BUILDING CODE OF AUSTRALIA COMPLIANCE ASSESSMENT REPORT

PROPOSED MIXED USE DEVELOPMENT

175-177 CLEVELAND STREET & 1-5 WOODBURN STREET, REDFERN

REPORT NO. ► 5567 – REV 02

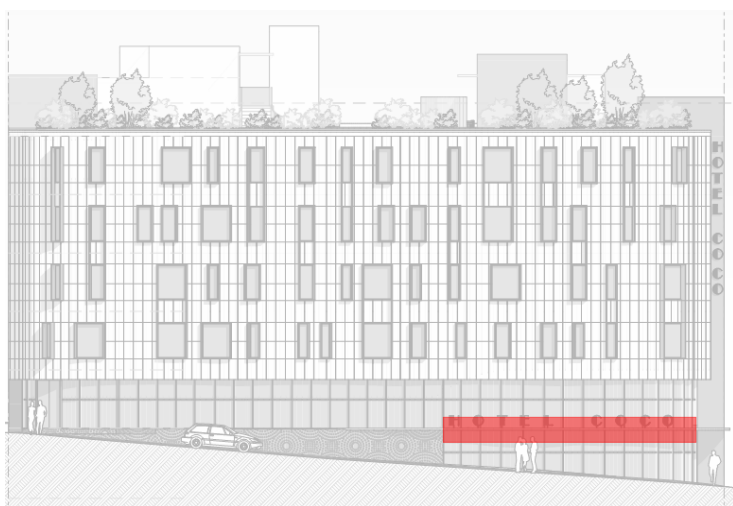
SECTION C FIRE RESISTANCE					
Part C1 Fire Resistance & Stability					
C1.1 Type of Construction Required				X	<p>Refer to Spec C1.1 and Attachment B for Schedule of FRLs for Type A Construction. These are to be certified by the architect and structural engineer as having been met, based on the proposed design.</p> <p>Please note that specification C1.1 also requires design compliance with the following:</p> <ol style="list-style-type: none"> Where a combustible material is used as a finish or lining to a wall or roof, or sunscreen, or awning, to a building element required to have an FRL the material must be exempted or comply with the fire hazard properties prescribed under C1.10 and must not otherwise constitute an undue risk of fire spread via the façade of the building or compromise egress from the building. This includes any aluminum panels which where containing plastic strengthening elements would not be non-combustible. Fire isolated shafts are required to be enclosed at the top and bottom of the shaft with fire rated construction as per specification C1.1. This fire

Northern elevation

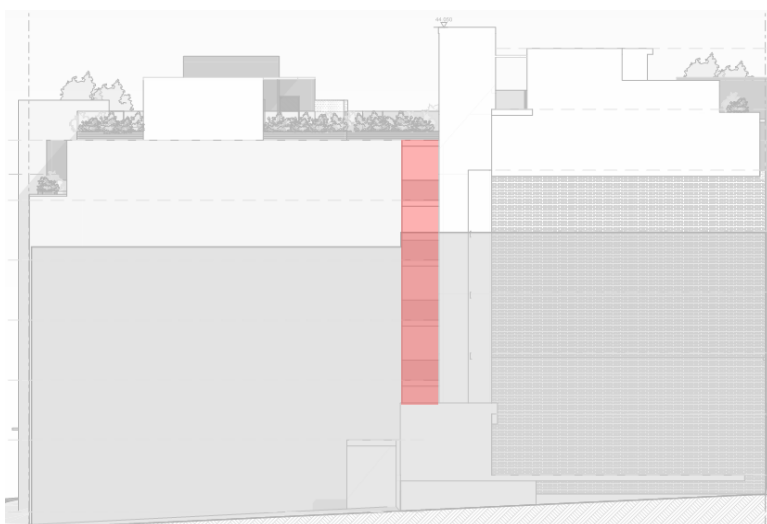
BCA DEEMED-TO-SATISFY PROVISION	COMPLIES	DOES NOT COMPLY	NA or Informational	Compliance Required	COMMENTS
Compartmentation & Separation					
C2.2 General Floor Area & Volume Limitations	X				There are no fire compartments shown to exceed the floor area or volume limitations of Table C2.2.
C2.3 Large Isolated Buildings			X		Not applicable
C2.4 Requirements for Open Space			X		Not applicable
C2.5 Class 9a & 9c Buildings			X		Not applicable
C2.6 Vertical Separation of openings in external walls				X	<p>The building is not required to be sprinkler protected under the BCA, hence all openings located in the external walls of the building that are required to have an FRL must comply with vertical separation requirements as stipulated under Clause C2.6, that is:</p> <ul style="list-style-type: none"> • They are protected with a 900mm high (FRL 60/60/60) spandrel extending at least 600mm above the separating slab, or • They are provided with a 1.1m horizontal projection (FRL (60/60/60) also extending at least 450mm either side of the opening. <p>Particular attention should be paid to openings being protected via a balcony slab to ensure that the slab extends outwards 1.1m.</p> <p><u>Compliance issue(s):</u></p> <ol style="list-style-type: none"> 1. The example openings highlighted in red below have not been indicated with spandrels on the plans as per the above requirements. 2. No elevations have been provided for the external openings facing the light court. However in assessing “Section A” plan it is indicated that compliance vertical spandrels have been provided to the window openings of Suite F and as such it is assumed that the other hotel suites facing the courtyard have also been provided with compliant spandrels. <p><u>Recommendation(s)</u></p> <p>Architect to provide compliant spandrels to the openings highlighted below and any other openings required to be protected with a spandrel. Details of spandrels to be provided at CC stage.</p>

BCA DEEMED-TO-SATISFY PROVISION	COMPLIES	DOES NOT COMPLY	NA or Informational	Compliance Required	COMMENTS
					<i>Details of compliant spandrel separation must be provided.</i>
